FINAL
ENVIRONMENTAL STATEMENT

CALLEGUAS CREEK
SIMI VALLEY TO MOORPARK
VENTURA COUNTY, CALIFORNIA

June 1976

PLATE 4
PRIME AGRICULTURAL LAND

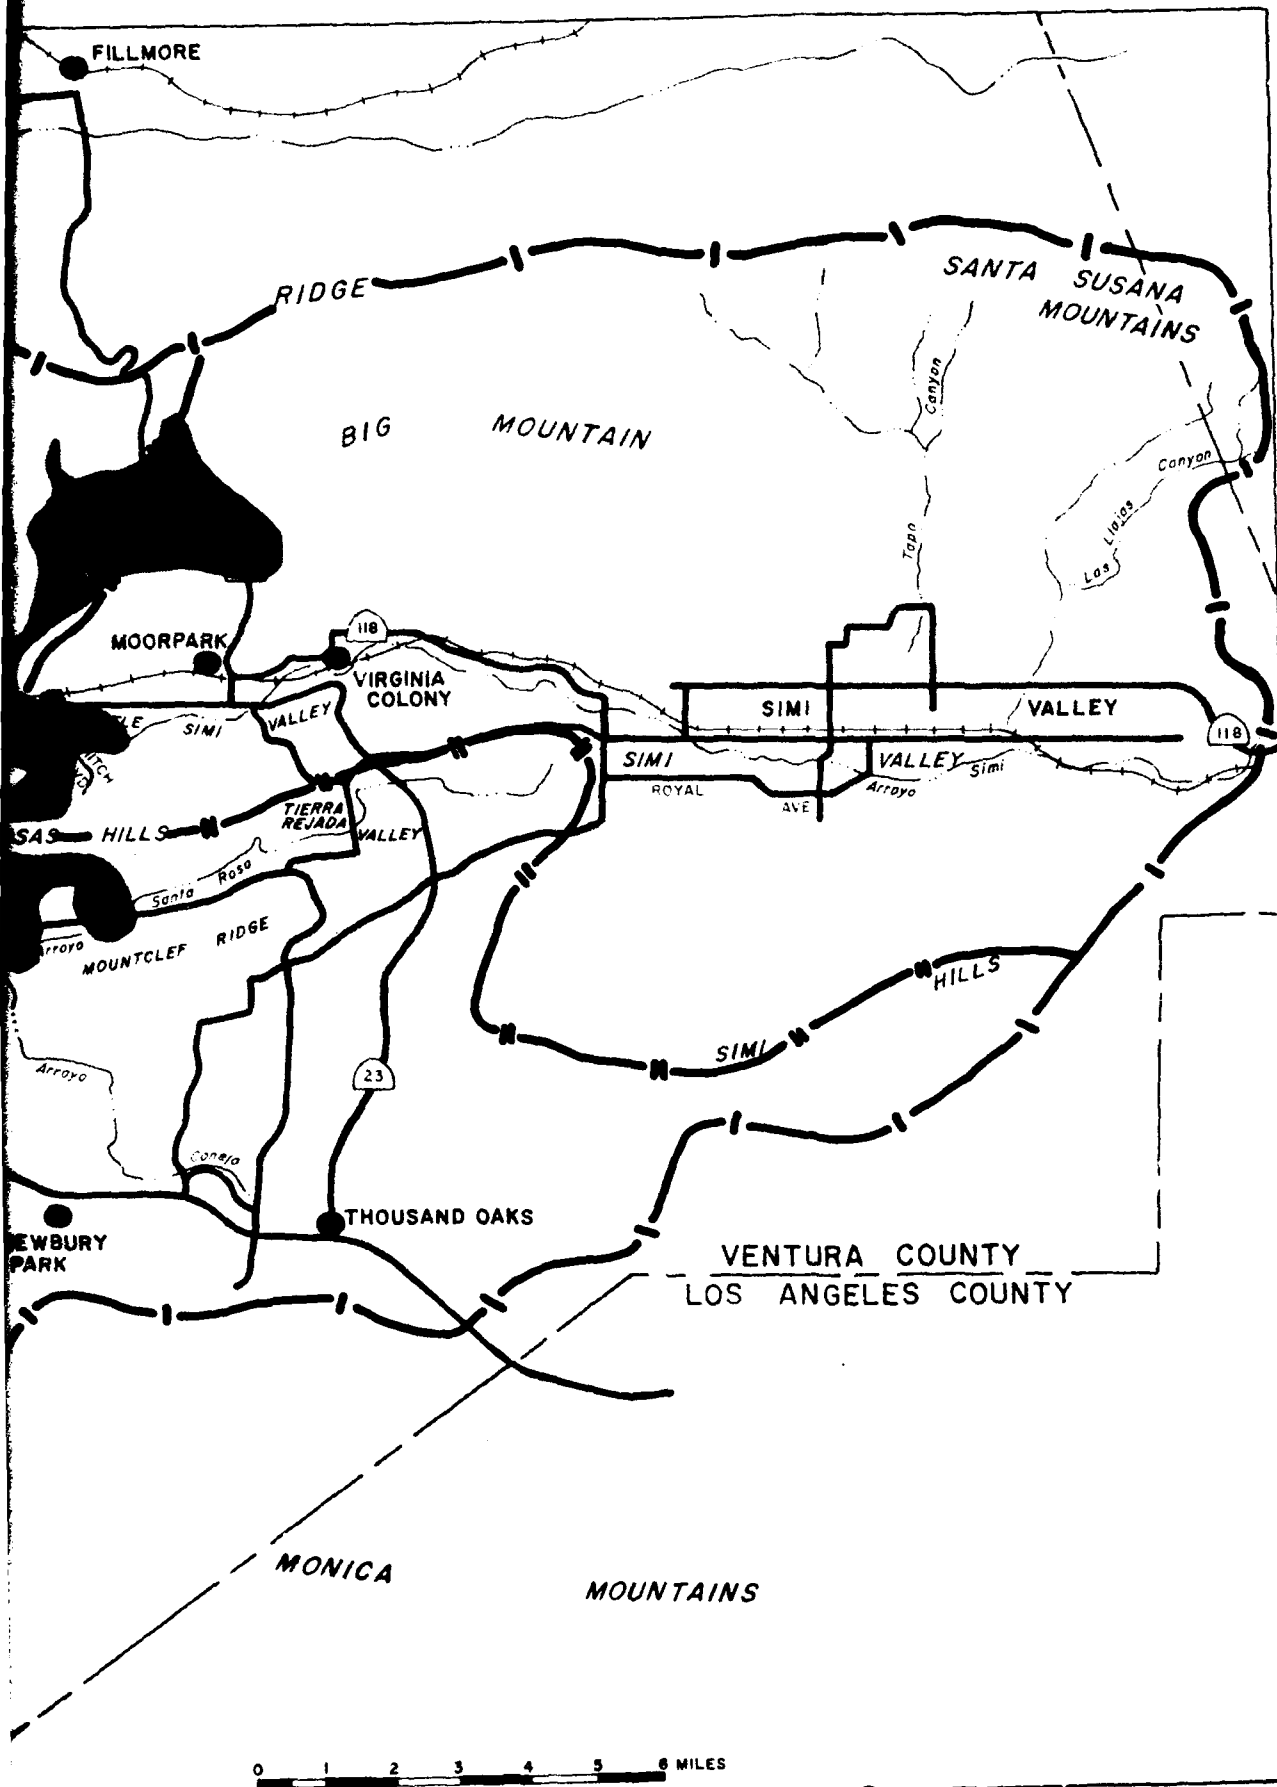
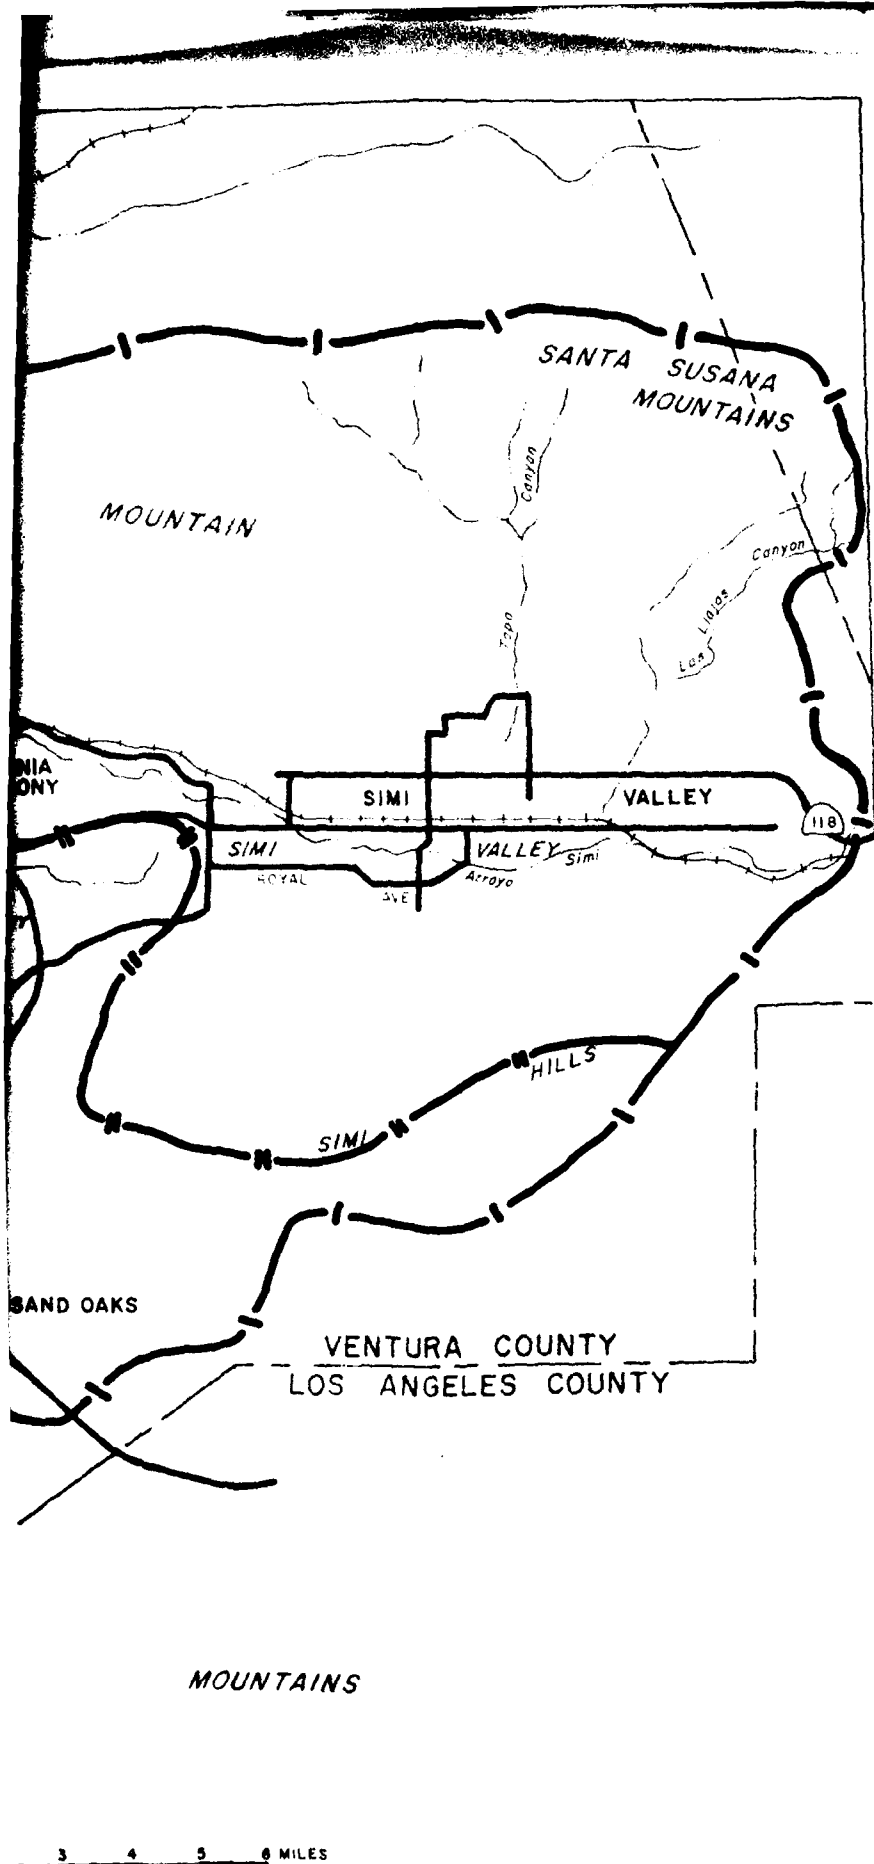
Comment: Plate 4 identifies prime agricultural land within Ventura County. For clarification purposes, the area shown on this plate is the Agricultural Element of the Ventura County General Plan as adopted by the Board of Supervisors.

11. Plate 4 identifies prime agricultural land within Ventura County. For clarification purposes, the area shown on this Plate is the Agricultural Element of the Ventura County General Plan as adopted by the Board of Supervisors.

PLATE 5
NATURAL COMMUNITY
DISTRIBUTION

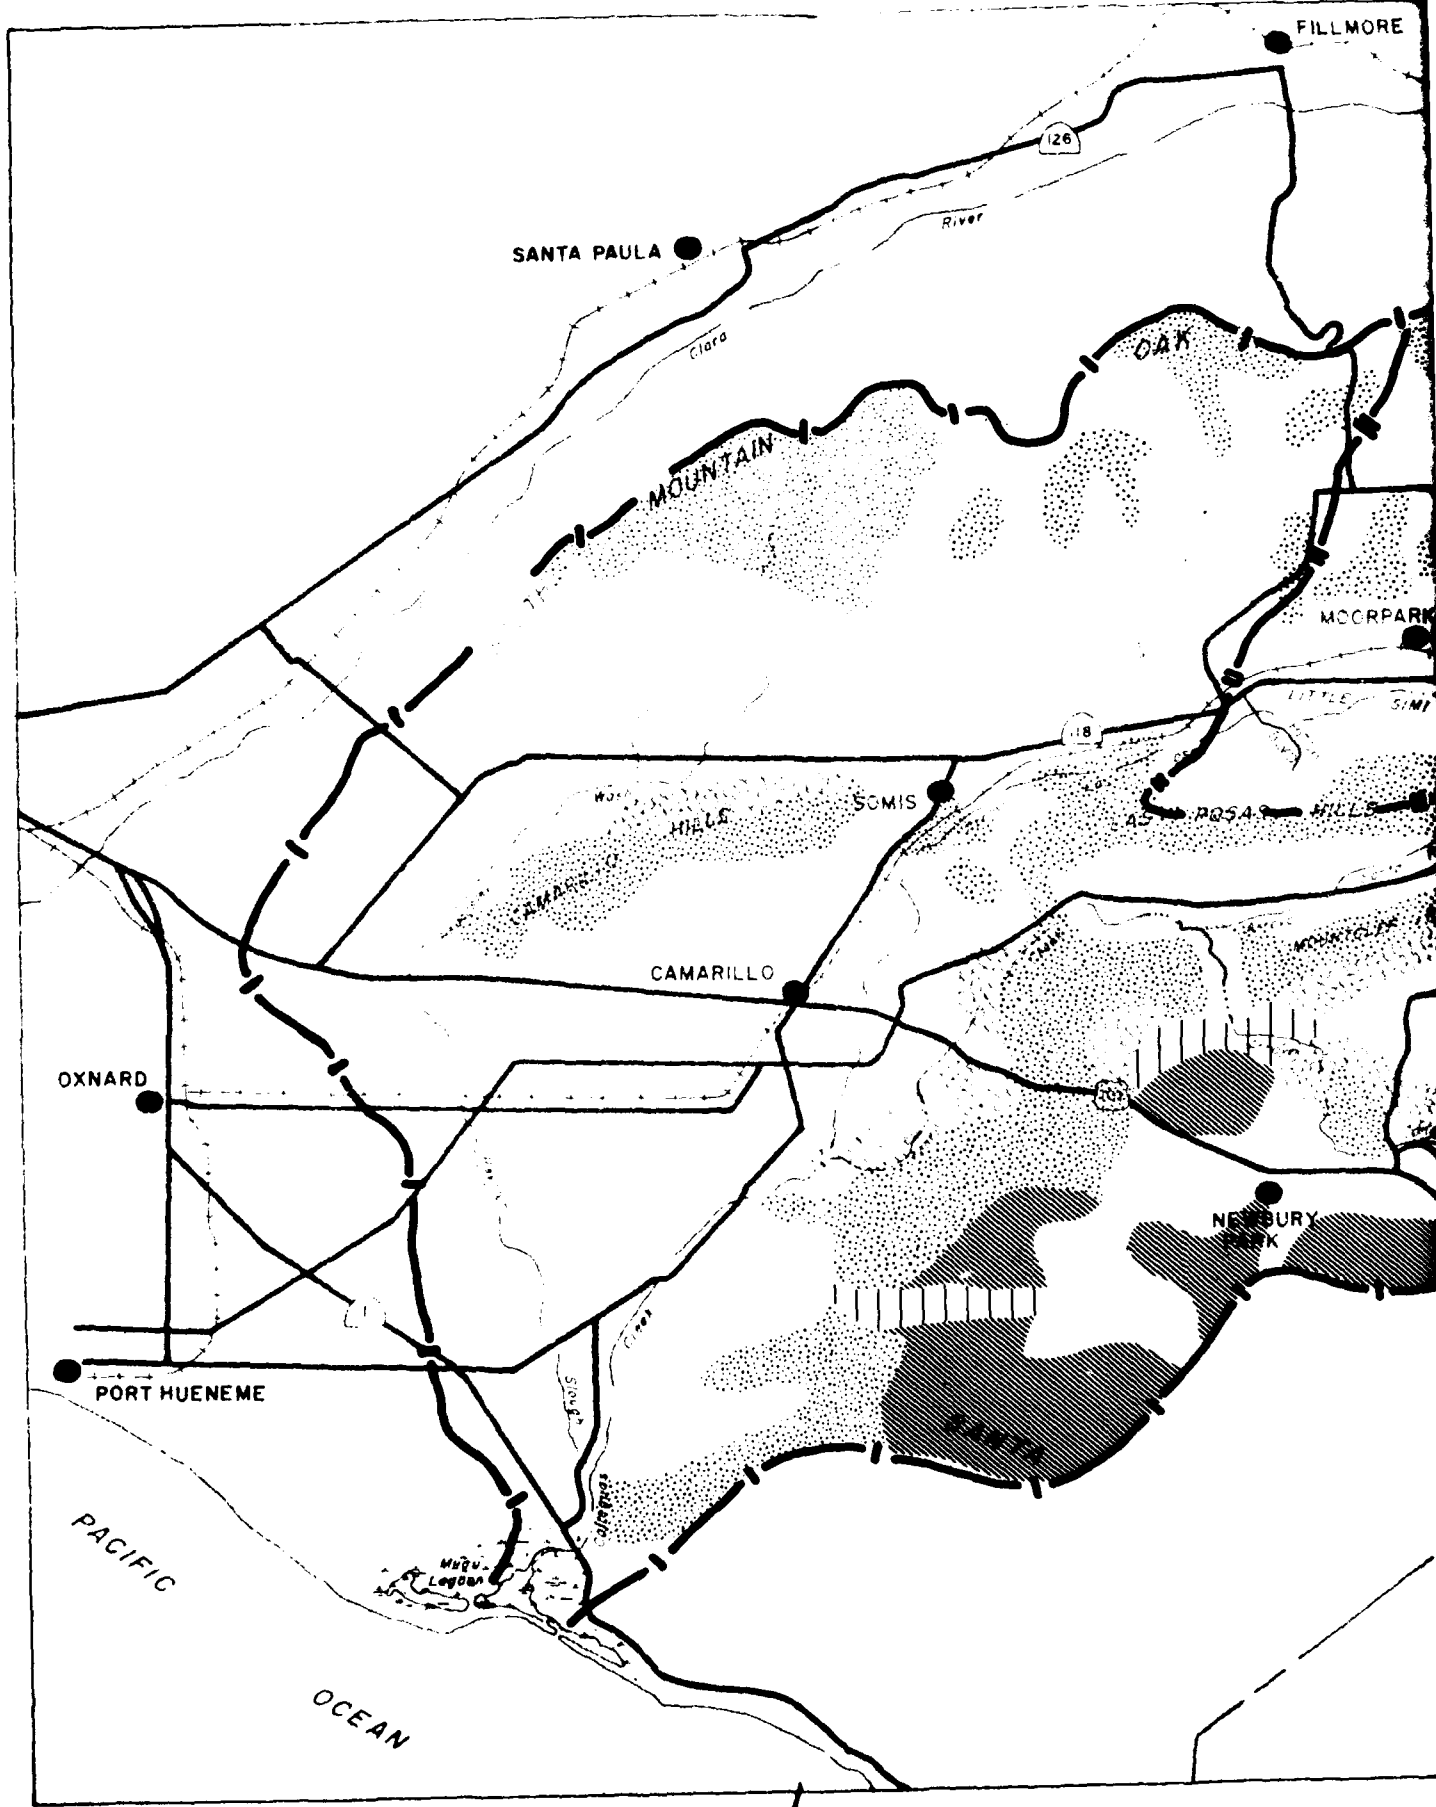
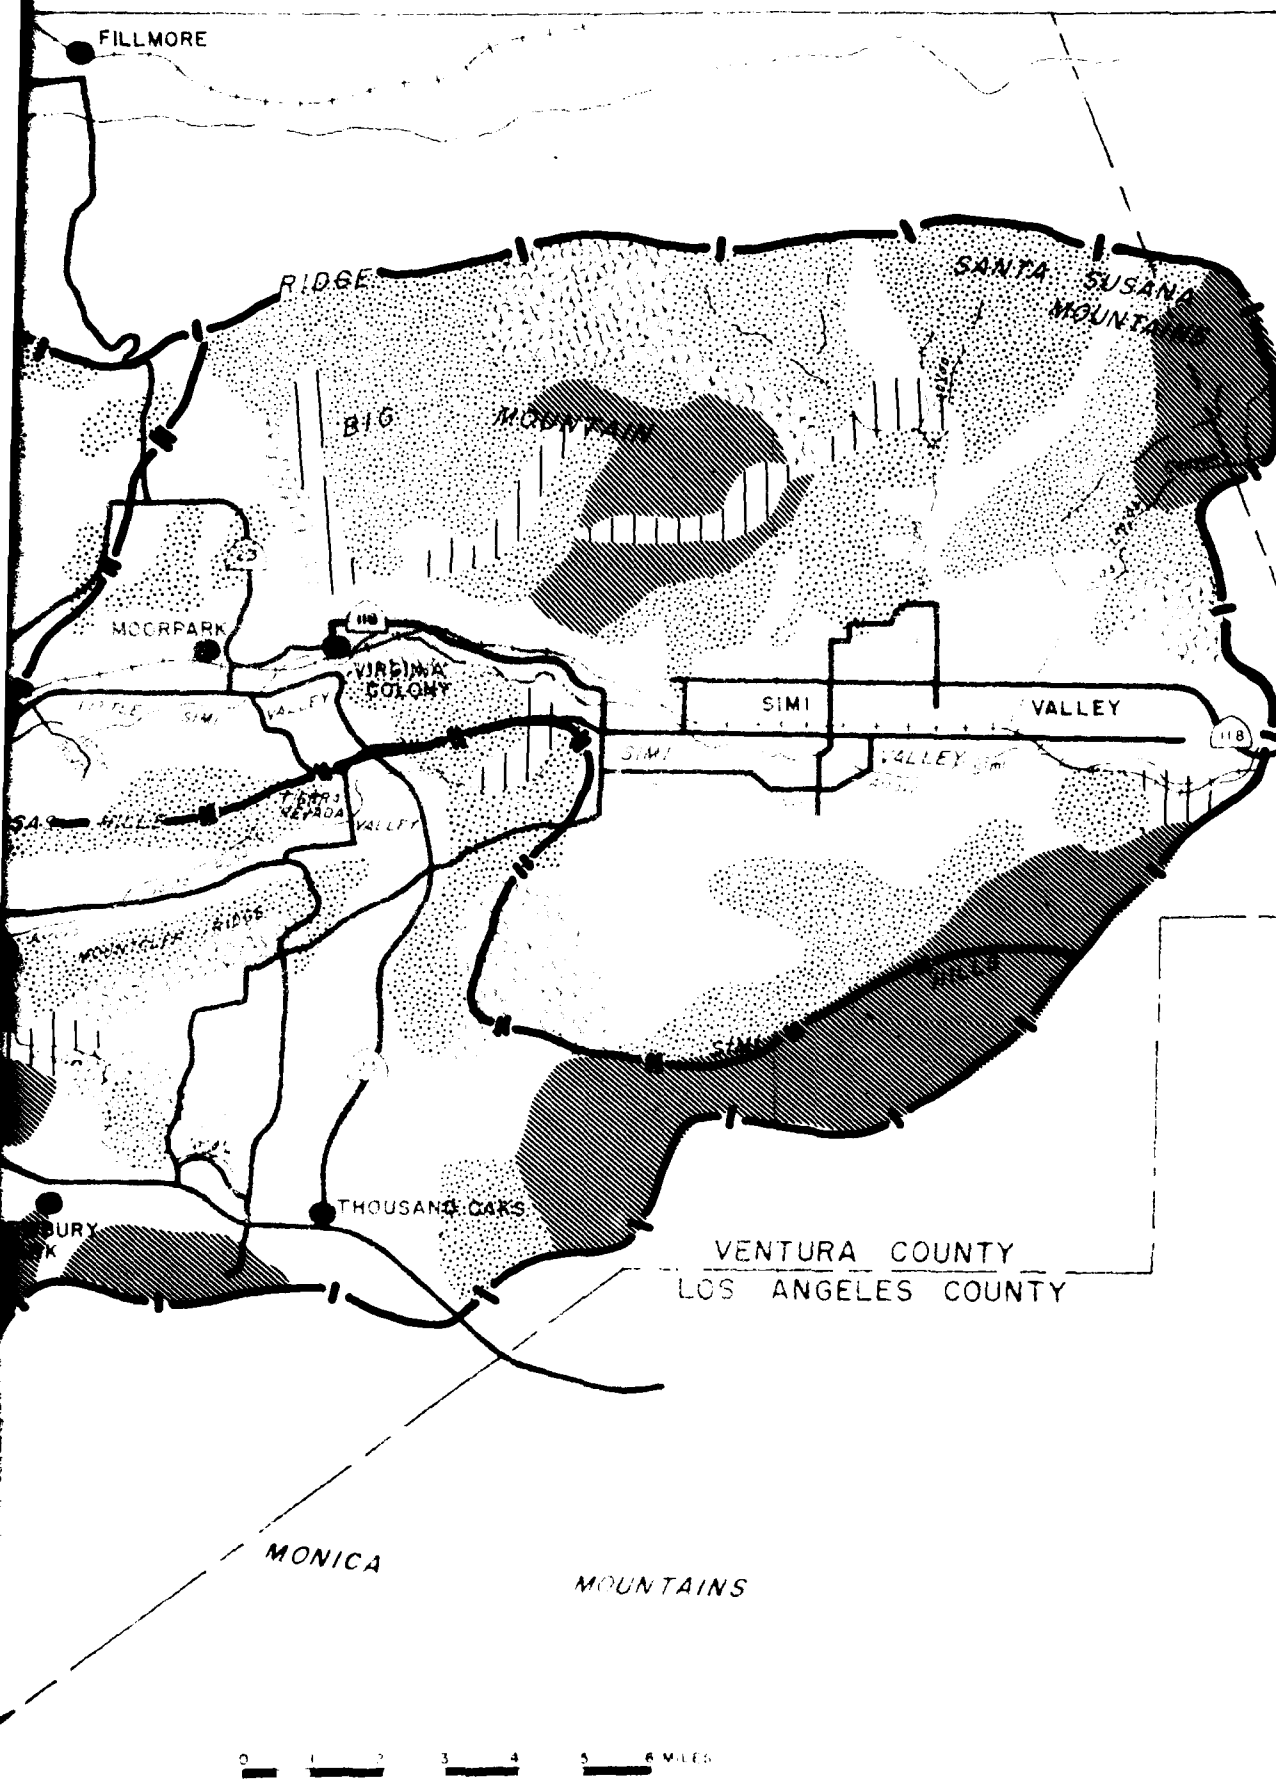
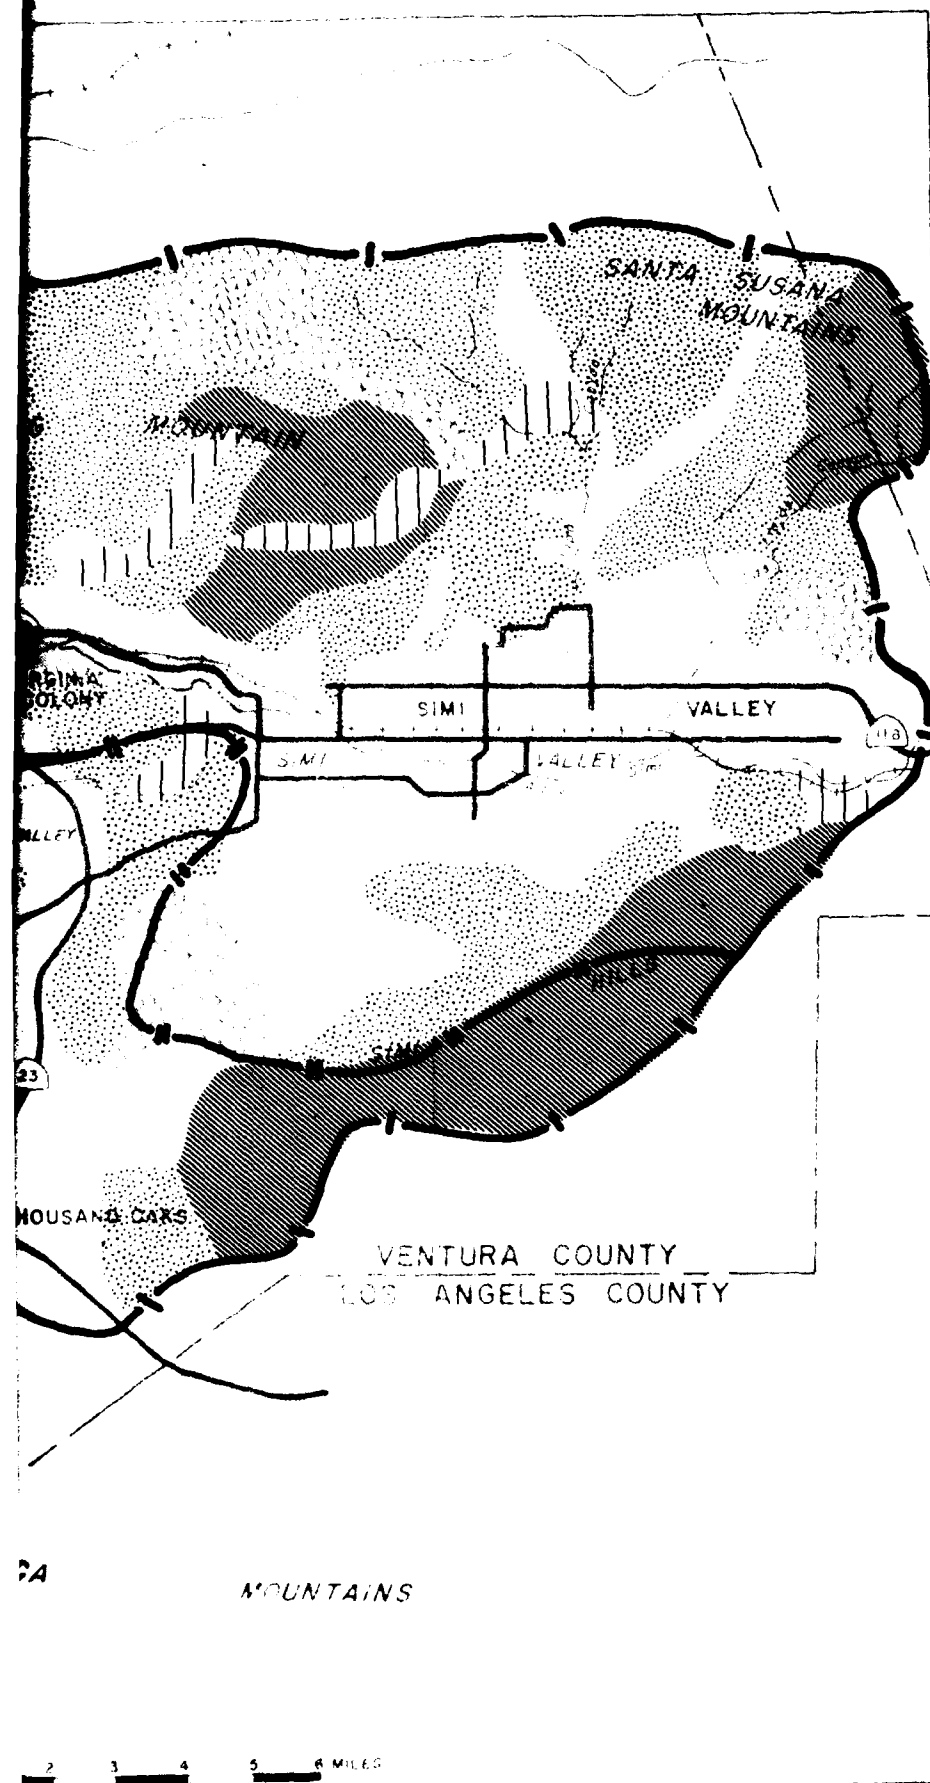
Comment: The statement should take cognizance of the project's impact on biological communities in the reach between Simi Valley and Moorpark. Perhaps more recent photographs should be included in the statement to indicate the lush vegetation that has developed in the area and this condition reflected in plates 5, 6, and 7.

Response: The only impact on the biological communities between Simi Valley and Moorpark would result from recreation trails and use of these trails. The environmental statement has been modified to reflect the impact of recreation on the biological communities. The photos were taken in the spring of 1973. Presence of bush riparian growth is dependent on the amount of waterflows in the streambed. Larger flows remove growth. Plates 5, 6, and 7 do reflect the riparian community in relation to the map topics.
